Access Compliance Report

Public Rights-of-Way

Intersection ID: 28350	Main Street: REA_RD	Cross Street: LINDAHI_LN	Location: SE
ADA ID: A2EE6F69B8E8	Ramp Type: PerpDiag	Initial Pass/Fail: Pass	Overall Compliance: No
Severity Score: 12.5			
Codes/Mitigation Info/Possible Solution		Field Measurements/Component Compliance

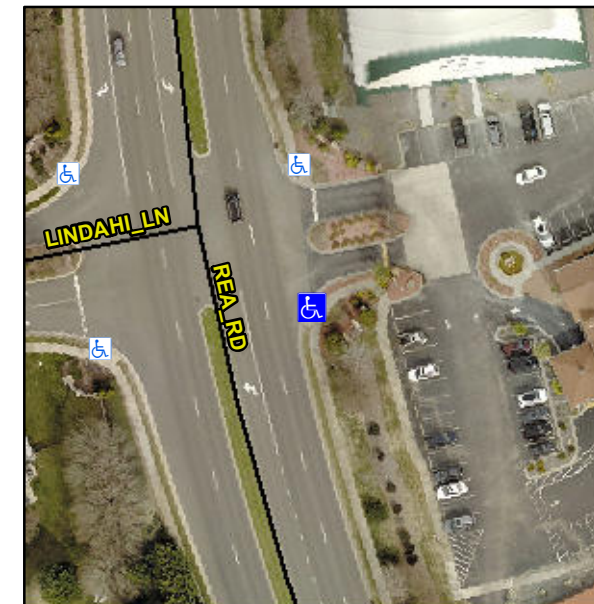
Not Found, R304.2.1, R304.2.2-Perp, R304.3.2-Para, R304.5.3, R305.1.4, R305.2

Compliance	Description	Data	Compliance	Description	Data
N/A	Ramp Length (in)	103.0	Yes	Ramp Slope (%)	5.8
Yes	Ramp Width (in)	65.0	Yes	Ramp XSlope (%)	1.8
N/A	Flare Type LT	Sloped	N/A	Flare Type RT	N/A
N/A	Flare Slope LT (%)	7.0	Yes	Flare Slope RT (%)	3.3
N/A	Flare Traversable LT?	Yes	N/A	Flare Traversable RT?	Yes
No	Landing Length (in)	N/A	Yes	DWS Provided?	Yes
No	Landing Width (in)	N/A	Yes	DWS Contrast?	Yes
No	Landing Slope (%)	N/A	Yes	DWS Length (in)	24.0
No	Landing X Slope (%)	N/A	No	DWS Full Width?	No
N/A	Landing Curb? (Y/N)	No	No	DWS Offset (in)	5.0
N/A	Shared Landing?	N/A			
Yes	Gutter Ponding?	No	Yes	Gutter Slope (%)	0.4
Yes	Gutter Lip Ht (in)	0.0	Yes	Gutter X Slope (%)	0.0
N/A	Painted X Walk1?	No	N/A	Painted X Walk2?	No
	X Walk 1 Direction	To N		X Walk 2 Direction	To W
N/A	X Walk 1 Width (in)	N/A	N/A	X Walk 2 Width (in)	N/A
	X Walk 1 Slope (%)	0.2		X Walk 2 Slope (%)	2.2
	X Walk 1 X Slope (%)	1.6		X Walk 2 X Slope (%)	0.2

Remove & Replace Curb Ramp With Two New Directional Ramps or Equivalent.
